PRODUCT / PROCESS CHANGE NOTIFICATION

1.1 Company		STMicroelectronics International N.V
1.2 PCN No.	ADG/17/10491	
1.3 Title of PCN	VN7016AJTR: Product Optimization	
1.4 Product Category	VN7016AJTR	
1.5 Issue date	2017-12-15

VN7016AJTR: Product Optimization

New Deep Down Set Lead Frame Version (ST Bouskoura /ST Shenzhen)

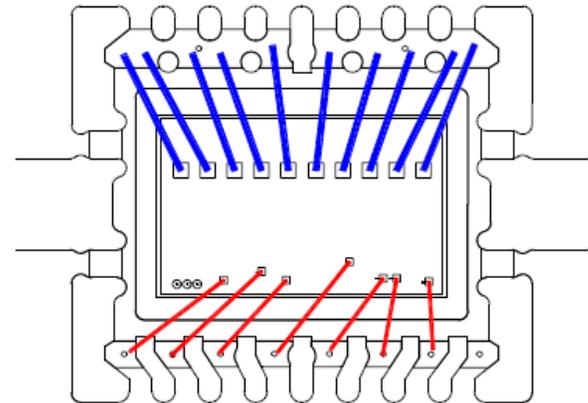
Current Lead Frame Version (ST Bouskoura only)

Pad size: 4.45 x 2.56 mm

Pad size: 3.61 x 2.49 mm

Exposed Pad Dimensions Difference

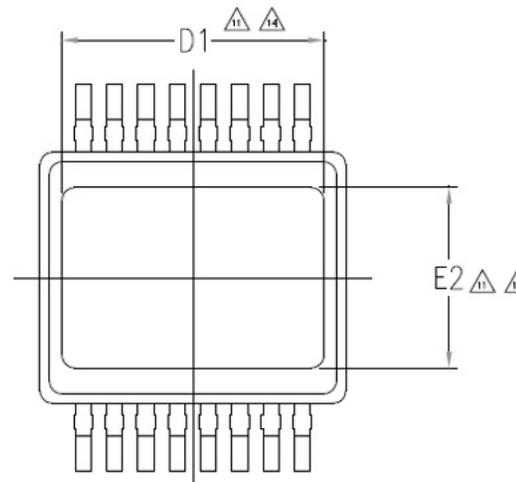
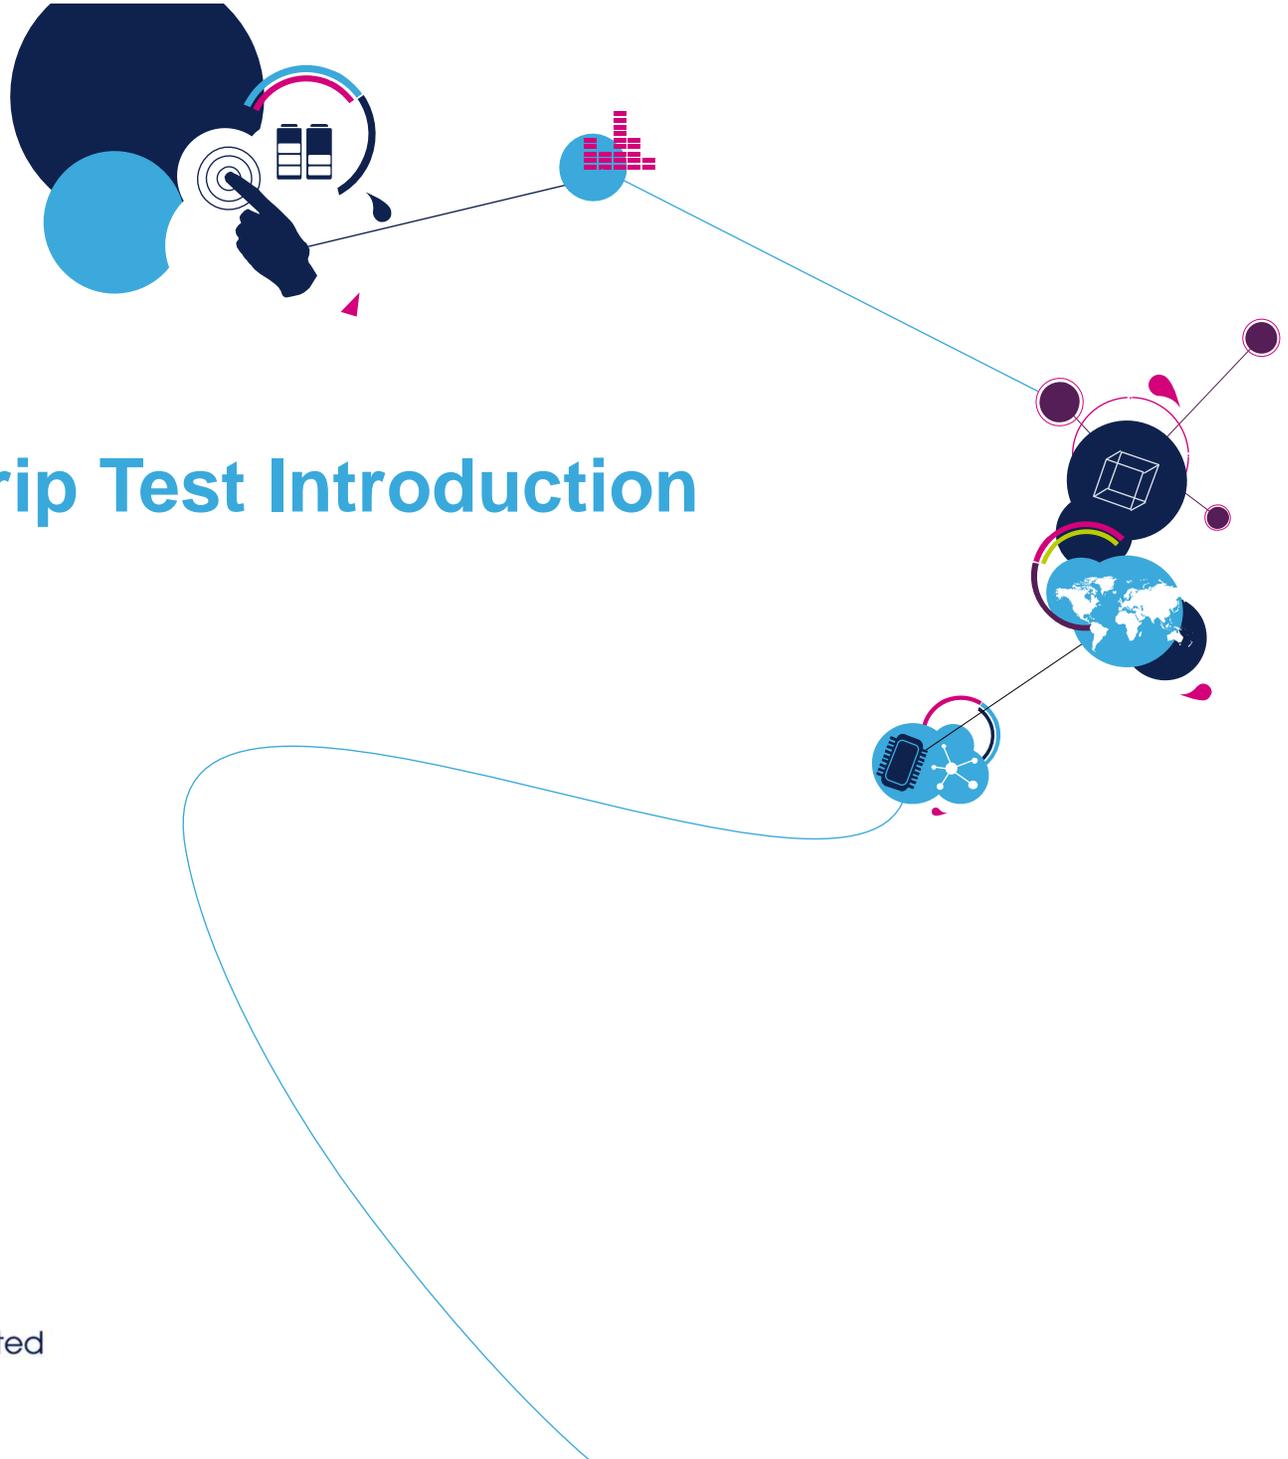
Current

min	typ	max
D1	2.6		4.2
E2	1.9		2.5

New

min	typ	max
D1	2.9		3.5
E2	2.2		2.8

PSSO Strip Test Introduction

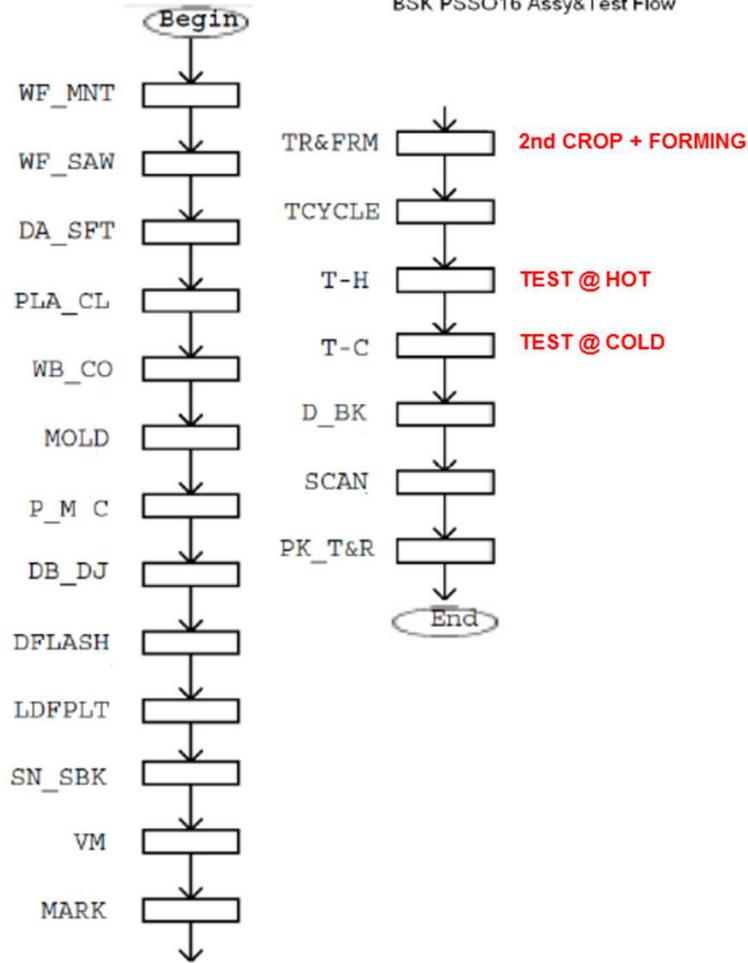
- Strip test is a new testing methodology that does not impact fit, form and function nor reliability of the products.
- Materials and equipments are not changed neither at FE nor at BE level
- Strip test is performed in between 1st crop (dam-bar cut) and 2nd crop (Trim&Form and final singulation)
- Further test step at ambient temperature is inserted after vision check

PSSO OLD vs NEW Flow

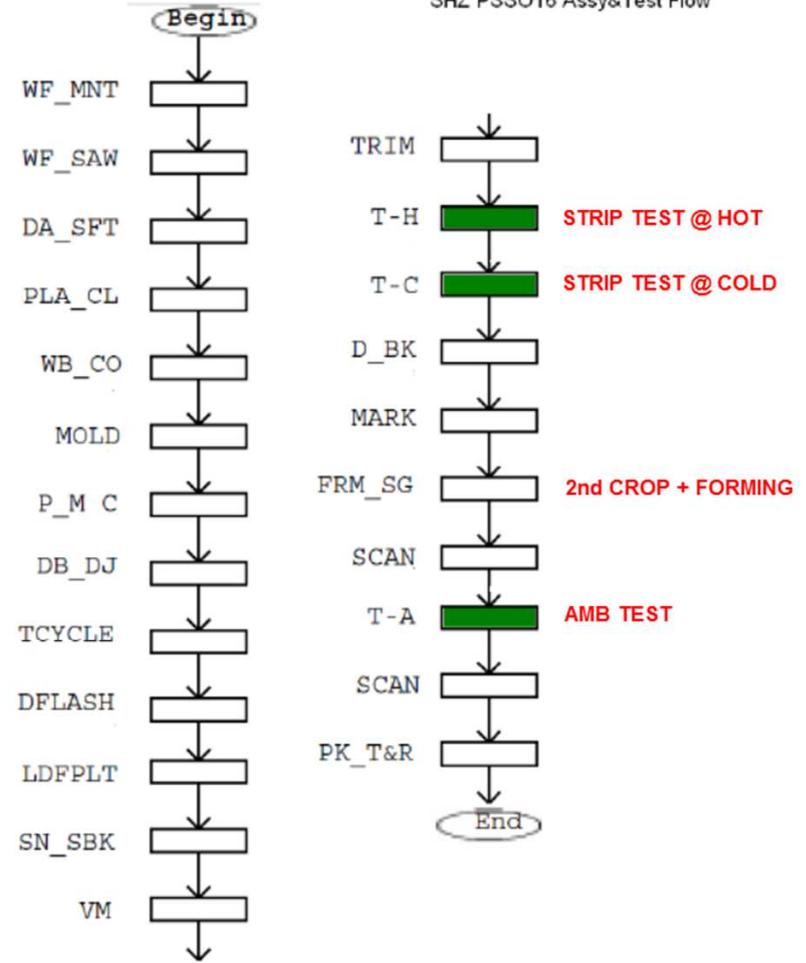
BSK PSSO16 Assy&Test Flow

SHZ PSSO16 Assy&Test Flow
